## **APPENDIX A**

### **TANK FARM DESCRIPTION AND CLOSURE PROCESS**

In November 2000, the Department of Energy (DOE) published the *Savannah River Site High-Level Waste Tank Closure Draft Environmental Impact Statement (DOE/EIS-0303D)* and invited public comment on the document. DOE held public hearings on the Draft Environmental Impact Statement (EIS) in North Augusta and Columbia, South Carolina, respectively, on January 9 and 11, 2001. The public comment period ended on January 23, 2001. DOE received written comments from 18 individuals and organizations and 8 people who spoke at the public hearings. DOE considered all comments in preparing this Final EIS.

This appendix provides the comments received and DOE's responses. Written comments and their responses are summarized in D.1. In Section D.2, each written comment letter is reproduced, with individual comments, questions, and suggestions labeled; responses to them are provided on the pages that follow each comment letter. If a comment prompted DOE to modify the EIS, the response describes the change and identifies its location in the Final EIS.

Figure A-6. Area closure example.

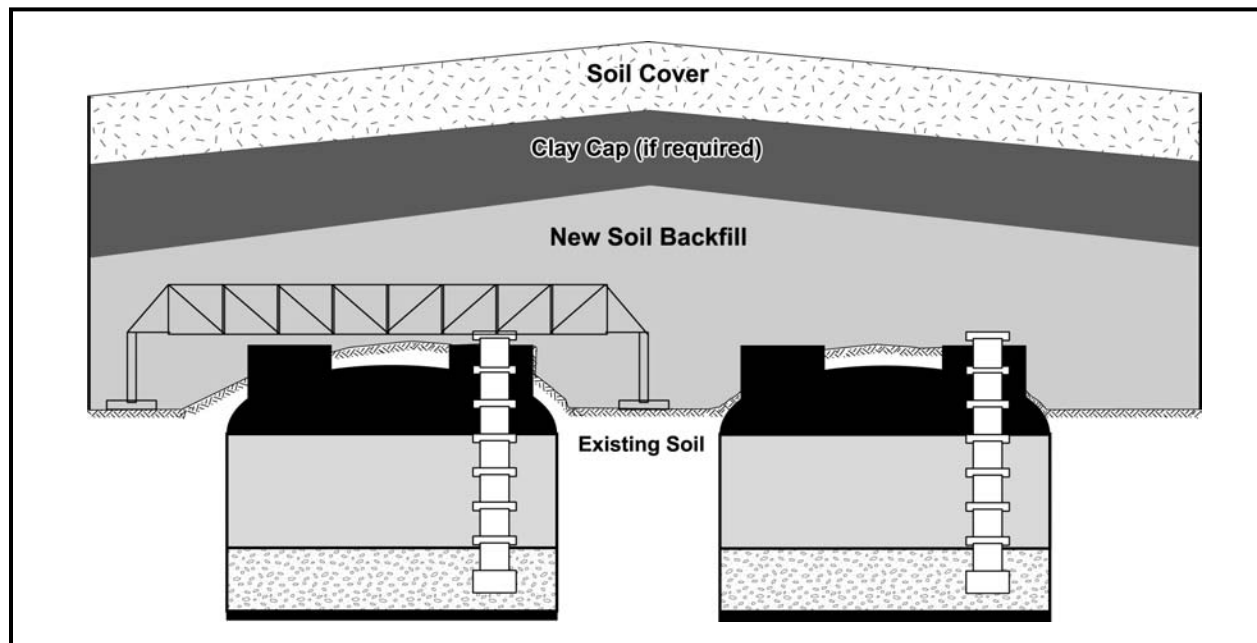
7. Page A-21: While helpful, Figure A-7 seems unclear. Describe the different elements inside of the tanks (viz., currently, the tanks are divided into four unnamed sections; contrast this figure with the clearer Figure 2.1-1). | L-2-21

Response to comment L-2-21: Figure A-6 is provided to present an environmental restoration concept with backfill material and a RCRA/CERCLA type cap shown over the closed tanks. See Figure A-5, Section A.4.4 (which is the same base figure as Figure 2.1-1) for more detail.

Figure C-2. Potential exposure pathways for human receptors.

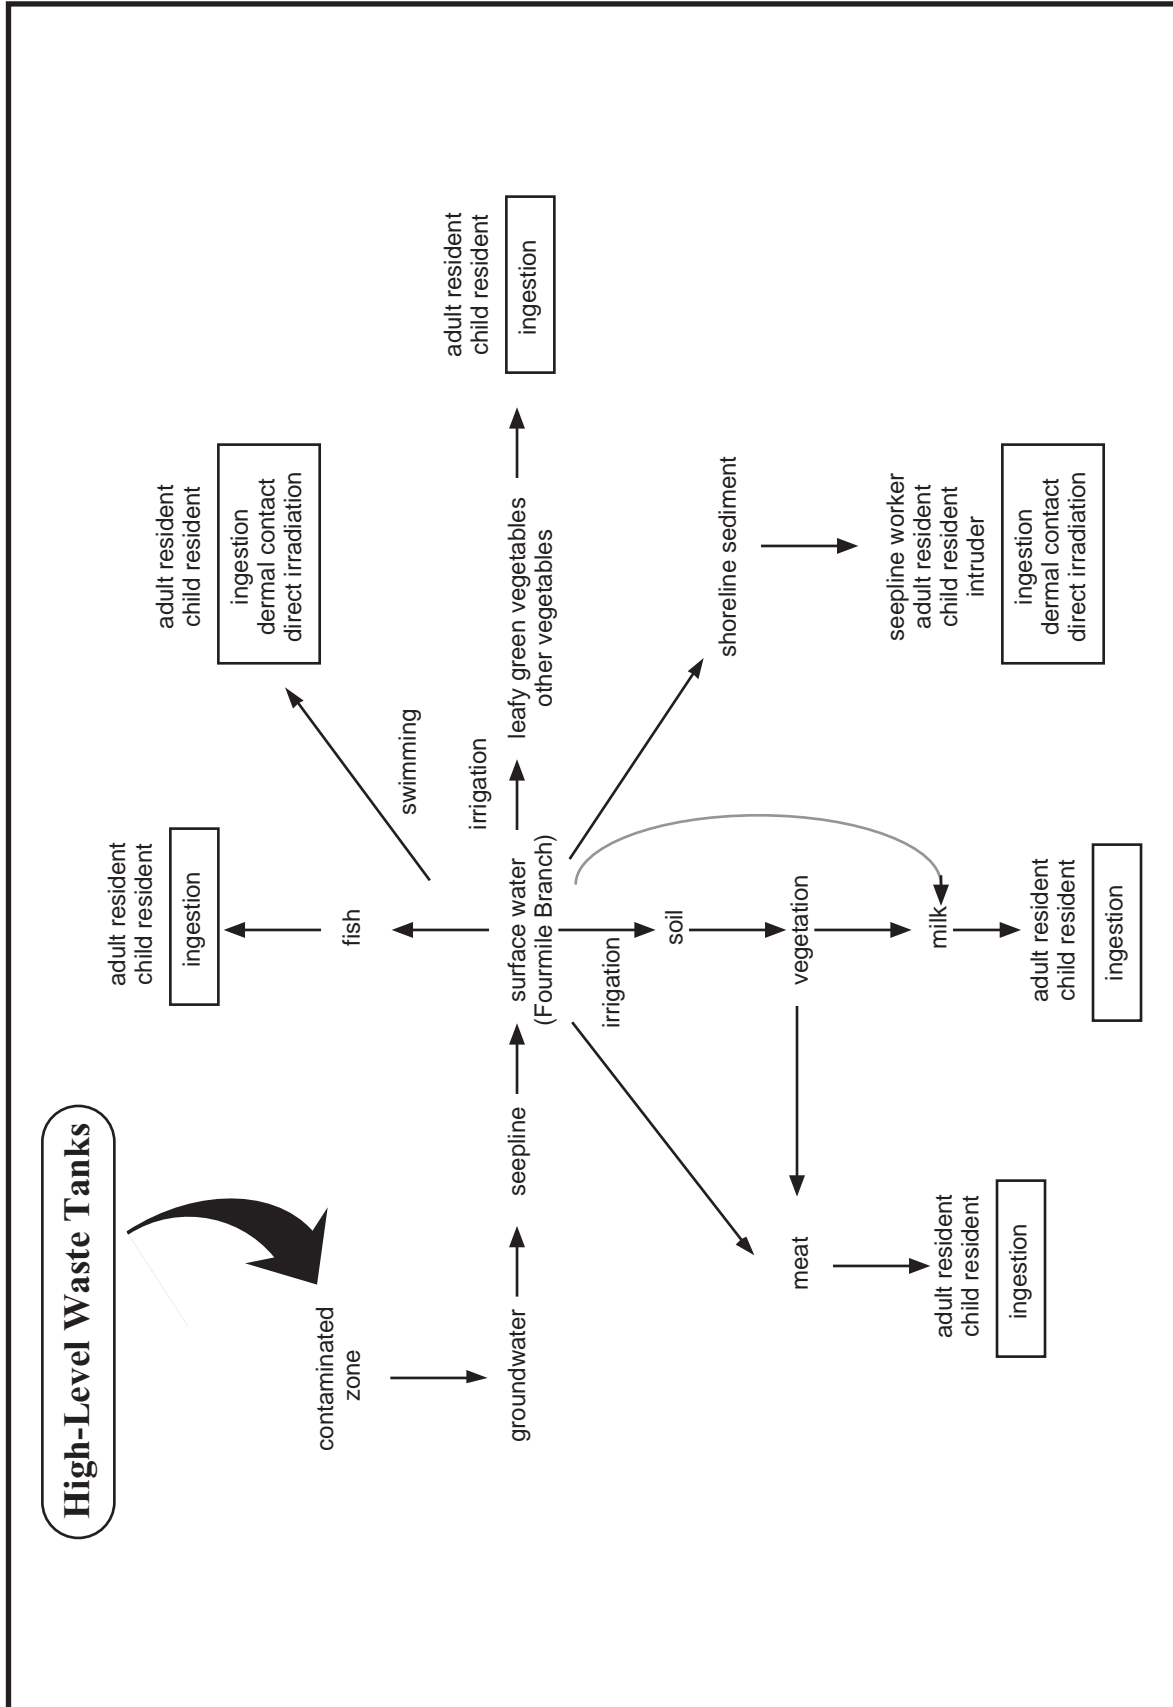
23. Page C-10, Figure C-2, Terrestrial Wildlife Column: When eating, the animals selected could also ingest sediment as well as soils. As a result, clarification is needed on page C-11, Column 2, last section regarding exposure routes. | L-4-26
